Dewberry Response to USGS Review of the Schoharie County NY QL2 LiDAR Project

Produced for U.S. Geological Survey

Report Date: 07/08/2015

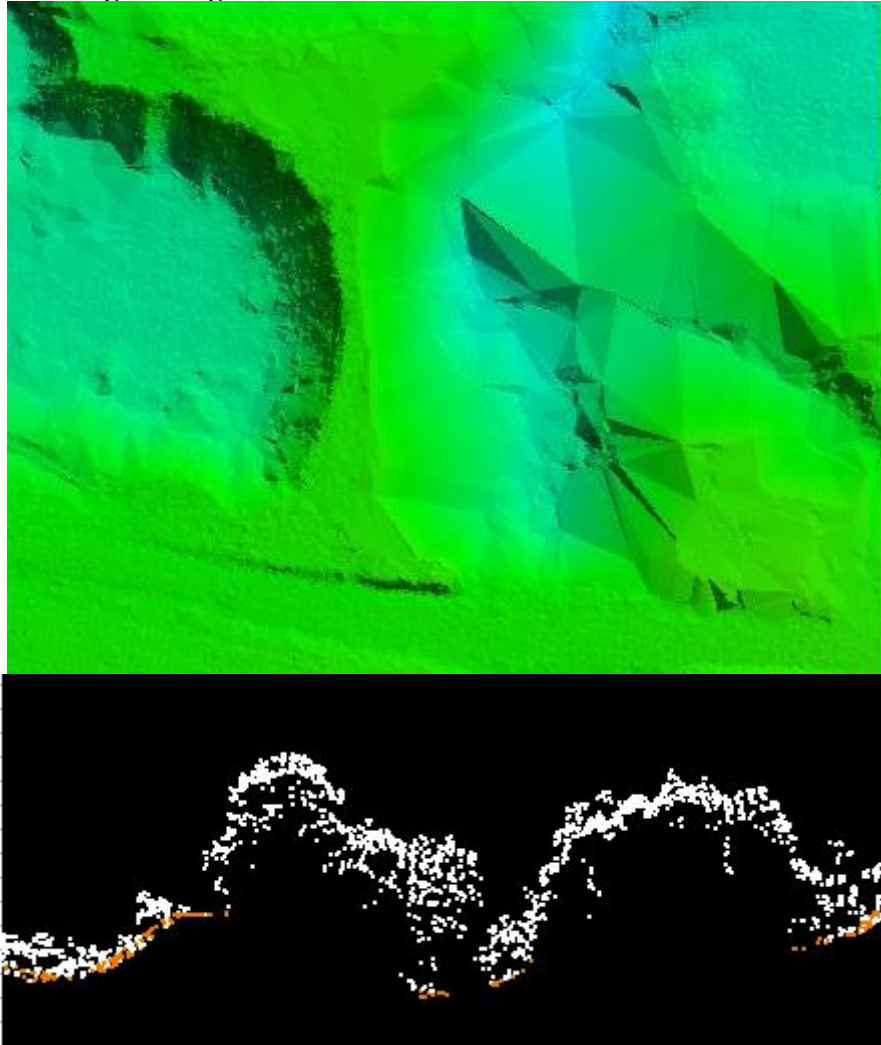
USGS made fifteen calls of areas that had excessive tinning. These calls were located in highly vegetated areas where ground points are sparsely classified. Dewberry was able to add some additional ground points in nine of the identified areas, but no additional points could be classified to ground in other areas. In these areas, the dense vegetation has prevented the lidar pulse from penetrating to the ground.

Figure 2- 18TWN235595. The above image is an overview of the DEM where USGS made an excessive tinning call. The below image shows a LiDAR cross section of the area. This area is highly vegetated and points cannot penetrate to the ground. There are no additional points to classify as ground to reduce tinning in these areas.

Figure 3- 18TWN460295. The above image is an overview of the DEM where USGS made a data holiday call. Dewberry has corrected the issue and no data holidays exist.

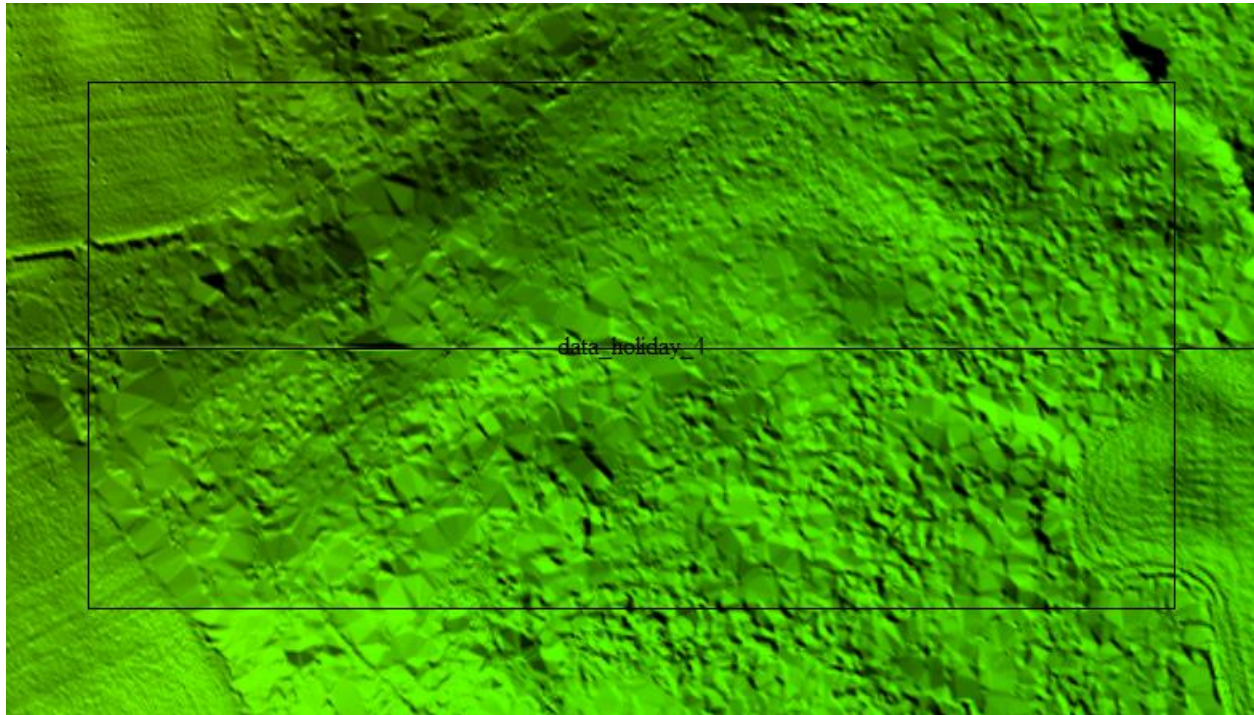
USGS made nine calls of data holiday. Dewberry has corrected all data holiday calls.

Figure 4 - 18TWN610295. The above image is an overview of the DEM where USGS made a tile edge mismatch call. The below image shows Dewberry removed the ground points that were causing the tile edge mismatch.

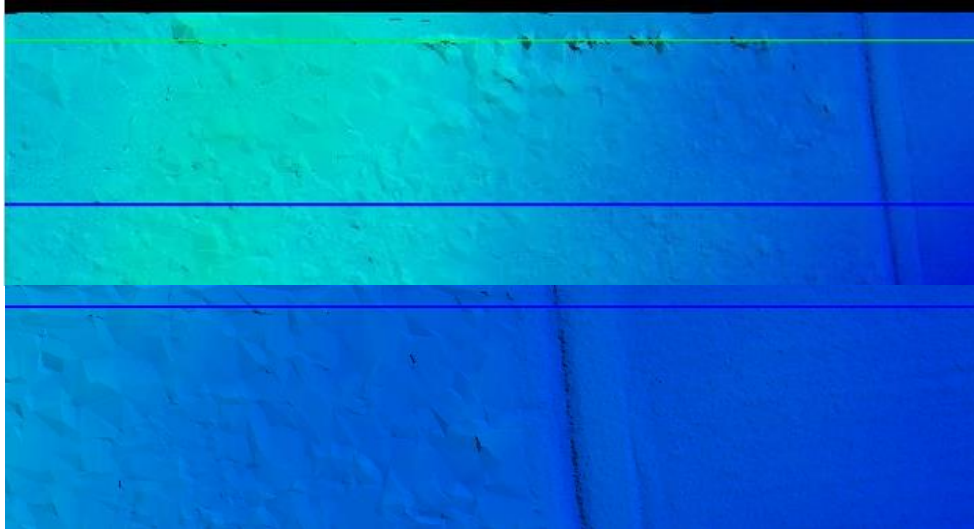
USGS made four calls on areas where the tile edge did not appear to be seamless. Dewberry reviewed these areas and removed the ground points that were causing the tile edge mismatch.

Figure 5- 18TWN580535. The image on the left is an overview of the DEM where USGS made a call to hydroflatten an area in the river. The image on the right shows an overview of the DEM after Dewberry hydroflattened the area in the river.

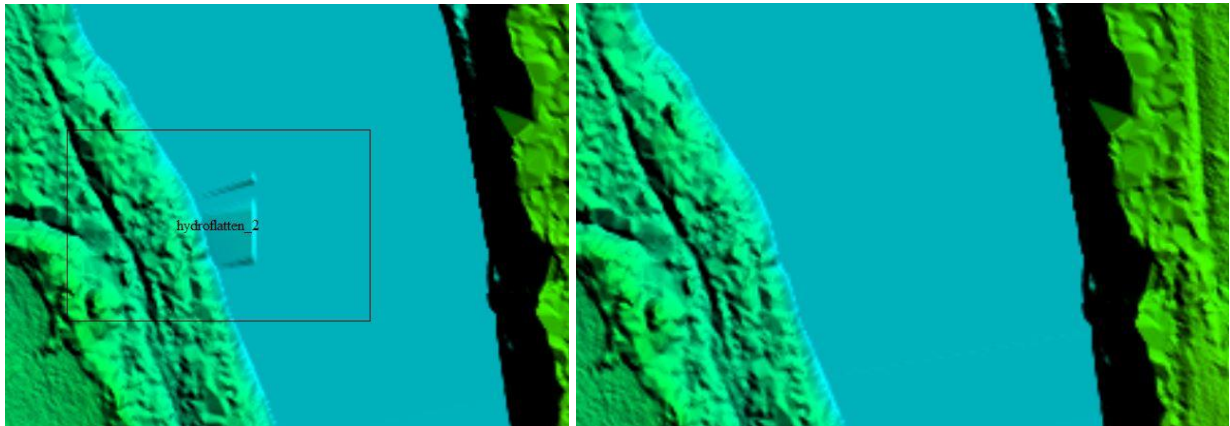
USGS made two calls where water artifacts in streams needed to be hydroflattened. Dewberry has corrected both locations.

Figure 6- 18TWN580535. The color imagery on the left depicts a dam where USGS made a call to remove a structure. The image on the right shows the bare earth DEM. Dams and other permanent flow structures are always modeled in the bare earth DEMs.

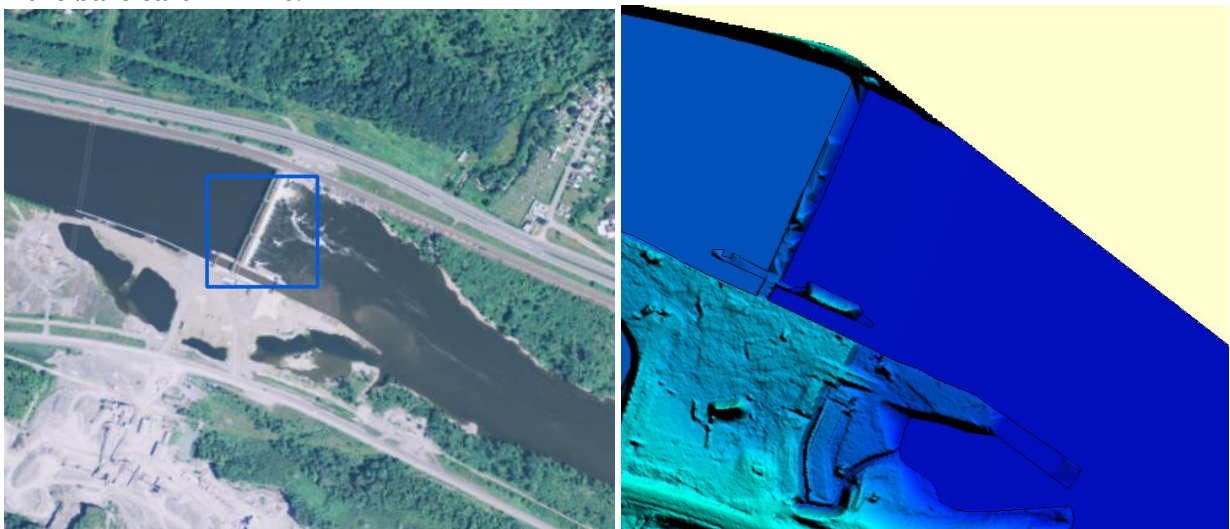
USGS made one call to remove a manmade structure. Dewberry reviewed the area and determined that this is a permanent hydrographic flow structure and should not be removed. Dams and other permanent flow structures that affect the flow of the stream are always modeled in the bare earth DEMs.
